**CITY OF ST. HELENS PLANNING DEPARTMENT
STAFF REPORT**

Appeal AP.1.25 – AP.3.25 of the Planning Commission’s denial of Variances V.1.25 – V.3.25

APPLICANT: Kevin & Katherine McCarter (also the appellant)
OWNER: same as applicant

ZONING: Moderate Residential, R7
LOCATION: 35732 Hankey Road; 4N1W-4AB-100
PROPOSAL: Variances (x3) for reduced side yard (setback), reduced lot size, and reduced lot width for a potential future land partition application

APPEAL AP.1.25 - AP.3.25 CITY STAFF CREATED MAP

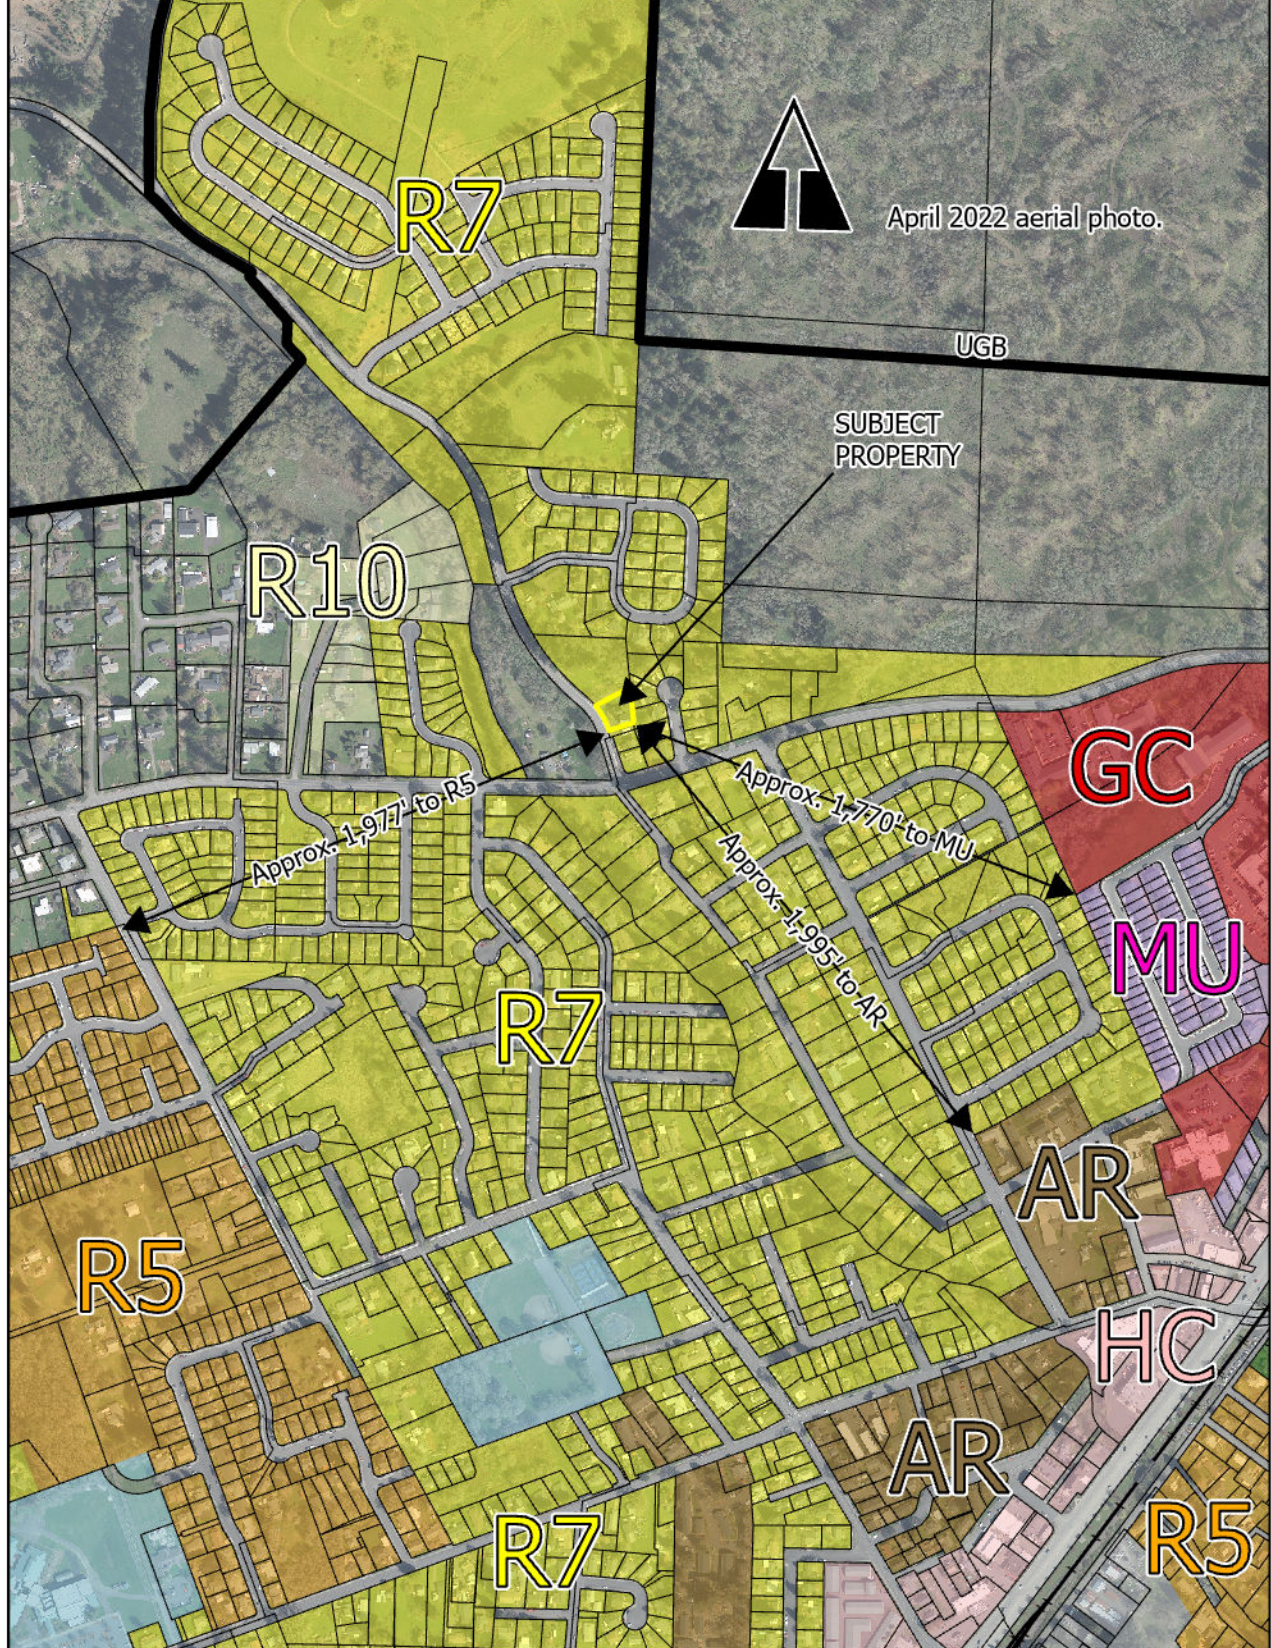
Parcel also owned by applicant.
Created by 2016 Lot Line Adjustment.

Long time existing access that provided access to the 1895 dwelling. This access was separated from the dwelling with the 2016 Lot Line Adjustment (and why a new driveway between the shop and Hankey Road was installed).

Proposed off-street parking area for 1895 dwelling (accessed via separate parcel).

Property line created by
2016 Lot Line Adjustment.

Detached single-family dwelling (1895)

Concept property line.

Driveway approved by 2015 Access Variance.

Attached garage/shop (2015).
Attachment unlawfully
removed 2021-2022.
